STAFF REPORT: 09/11/2024 REGULAR MEETING

APPLICATION NUMBER: HDC2024-00435

ADDRESS: 4031 FULLERTON

SCOPE: REPLACE STEEL SASH WINDOWS WITH COMPOSITE WINDOWS

Fig 1, by Applicant, 2024: Front (North) showing proposed window replacement locations.

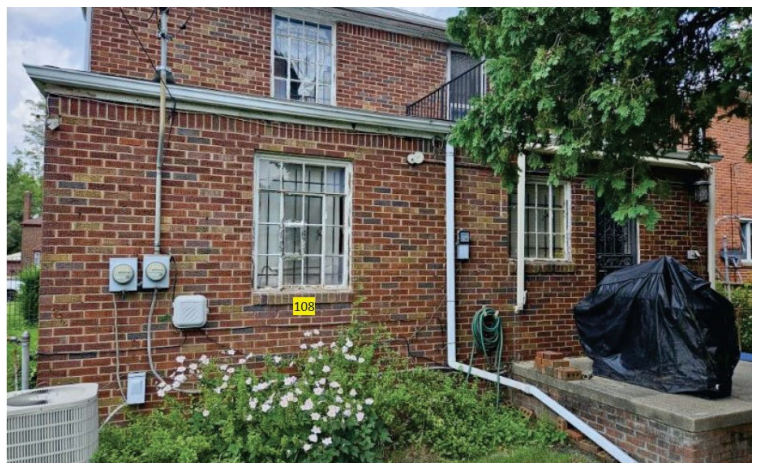
- Front (north), (Windows numbered 101-103, 202-204, *See fig. 1*): Replace six (6) steel casements with Anderson Renewal composite fixed and casement windows. The transoms and sidelights of the existing windows will be replaced with full operational casements at the side bays (101, 103, 202, and 204), whereas the casements, transoms and sidelights of the front facing windows will be replaced with fixed windows.
- Rear (south) (Window numbered 108, *See fig. 2*): Replace one (1) steel casement with Anderson Renewal composite casement window. The transoms and sidelights of the existing window will be replaced with full operational casement, with 4x4 configuration.

- The front and the west side windows are particularly visible from the public and are proposed for replacement with fibrex windows. It is staff's opinion that these true divided-light, steel casements are distinctive character-defining features. Their loss would substantially detract from and destroy the historic appearance of the building. (See photos 1-2, Figs 1-4)

- In addition to a material change from steel casements to fibrex, the design and operation of the windows would also change. For example, the front elevation casement windows would change to fixed windows (Windows 102 and 203), and the flanking casements would lose their transoms with the whole height of the windows being operational casements (Windows 101, 103, 202, and 204).

Figures 4&5, by applicant 2024: Window #104, west side, showing casement window condition with foam applied to exterior.

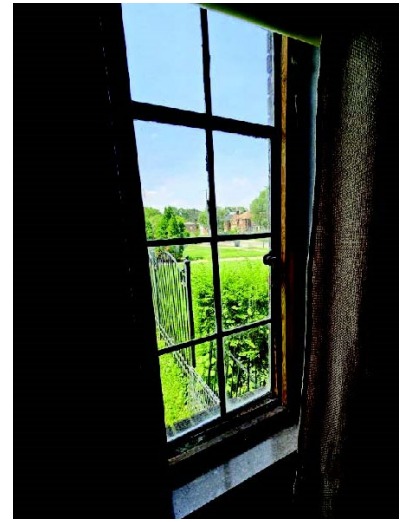
- Staff reviewed the exterior and interior photos of the casements provided by the applicant. Although there does appear to be some corrosion along the west elevation windows where spray foam was applied to the exterior, staff does not see evidence that these or any of the other casements are beyond repair. Wire brush cleaning of the area, along with replacement of glass panes where needed, the replacement of operation cranks, and similar work appear to be within a reasonable range of repair.

Figure 7, by Applicant: This illustrates existing (left column) and proposed (right column) dimensions of the mullion pattern for the casements

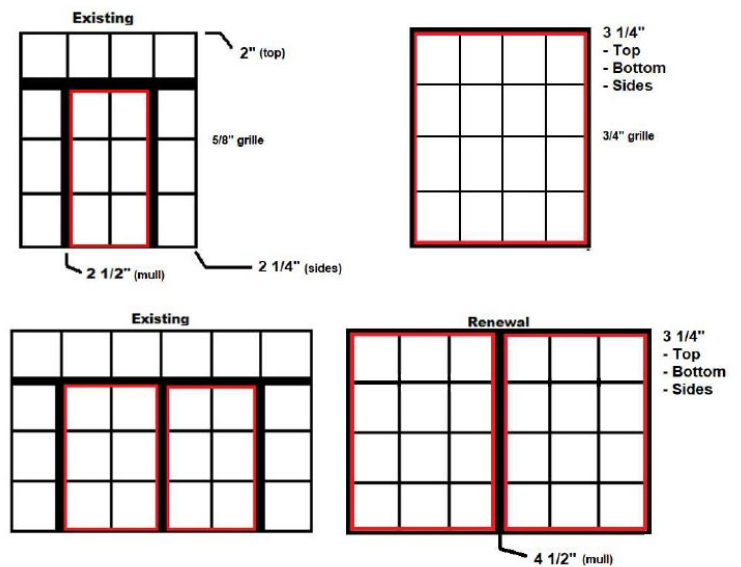
- Staff requested dimensions for the proposed casements and received the comparison of the existing and proposed mullion dimensions (see fig. 7) and the section dimensions of the proposed casements (See fig 8). Staff observed how these dimensions increase in width, ignore the existing transoms and sidelights, and provide a bulkier appearance in the head and jamb.

- Alter the operator frame location, width and depth dimensions.
 - Slight differences in the dimensions of the muntins and frame has a noticeable effect on the overall character of the window. These proposed changes are noticeably larger, increasing the top frame dimension, for example, from 2" to 3 1/4". (See figures 7&8.)

Figure 9, by Applicant: This is a mock-up to illustrate the use of the "L-Trim" aluminum coil stock that would be set between the window and brick opening.

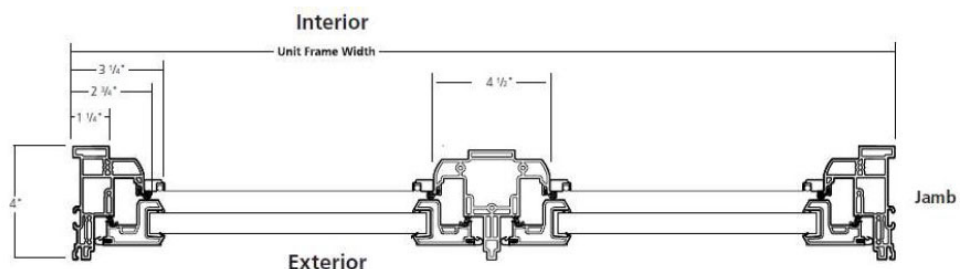
- Staff received confirmation that the brick mould would be removed and an aluminum or fibrex "L trim" (see fig.9) be installed between the window opening and the new casements. This L trim does not meet NPS guidelines, which necessitates that any replacement of steel sash windows with a new frame should be of minimal dimension.
